#### Memorandum from Department of Building Inspection, Portland, Maine

709 Congress Street-Testallation of 2-2,000 allow massline tenks for the Texas to. by f. H. Stokes, installer

Subject: Alteration of checking-out counters and exterior doors in the A & P supermarket at 713 Congress Street

Subject: Amans of egress from supermarket at 713 Congress Street

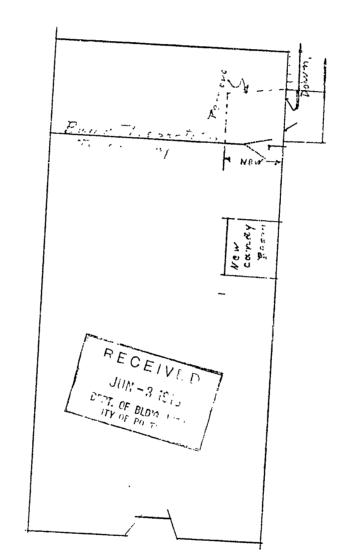
One of those changes affects the Pear emergency exit. Where the emergency exit door to the outside platform can now be reached without passing through any other doorway, the new arrangement will require customers to reach the emergency exit to pass throw hithe new doorway in partition parallel with Congress street. It is to be borne in mind that the door in the new doorway is to swing outwards, or be double-acting (it is indicated as double-acting on the plan) and is to be either without locks of any kind or else equipped with a vestibule lockset.

This may also affect the exit sign which was require: when the building was built to indicate the rear emergency exit and which should be now in place. An exit sign with letters in the word exit showing red no less than six inches high and on appropriate background should be provided wither over the door in the new doorway or clase in such position with a directional arrow so that it will be visible to all persons in the customer space without obstruction by new enady room partitions and show clearly what direction to take to reach the emergency exit door.

It is also to be borne in mind by the operators of the store that the passage-way between the new doorway and the partition extended, to the exterior exit door is always to be kept free and open. Now that the cartition is to be removed around what was the hallway, there will be the tendency to obstruct this passageray. I recommend that a stout railing, perhaps with a gate in it to serve employees, be constructed between the new doorway and the outside exit door to serve notice on all employees that the passageray is to be topt clear. Obstruction of this passageway round, of course, be a violation of law.
